CONSERVATION TEAM CONSULTATION APPLICATION RESPONSE

APPLICATION REF:	25/01553/FP
CASE OFFICER:	AHD
APPLICATION SITE:	54 Church Street, Baldock, Hertfordshire SG7 5AF
DESCRIPTION OF WORKS:	Change of use and conversion of existing building from Class E to residential use to create 1no two-bedroom flat and 2no one-bedroom flats, including external alterations to existing fenestration, insertion of first floor side entry doors and windows, installation of side external staircase and erection of refuse and cycle stores.

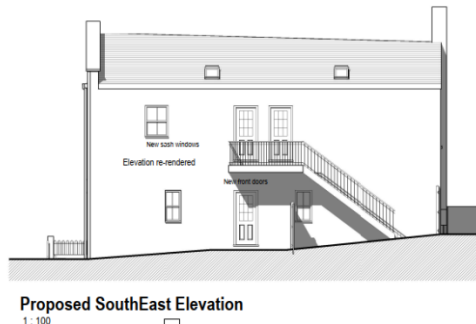
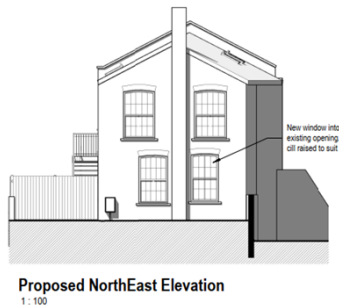
Previously I said that the proposed first floor flats are shown as 39m² and 37m² and do not have built-in storage. These have now been added, and I note the architect's clarification re: compatibility with The Technical housing standards – nationally described space standard (March 2015) i.e. the first-floor flats are 1 bed 1 person size, which are min 37m² with a shower provided.

I also said that the ground floor rear window should be designed to match the proportions of the ground floor window alongside and that the proliferation of openings on the side elevation is a concern. Both matters have been addressed, and the scheme is acceptable in this regard.

I have one further observation, which being that I was previously asked for my on the replacement windows being timber-alternative sashes from the Rose Collection rather

than timber and I considered this acceptable in my lats comments. However, the latest amended drawing still refers to new windows being painted timber.

- 1. Notwithstanding the reference to new windows being 'painted timber' on amended drawing no. 04 F, the new windows shall be vertically sliding sash types either manufactured in timber or timber-alternative sashes from the 'Rose Collection' unless otherwise agreed and approved in writing by the Local Planning Authority.**
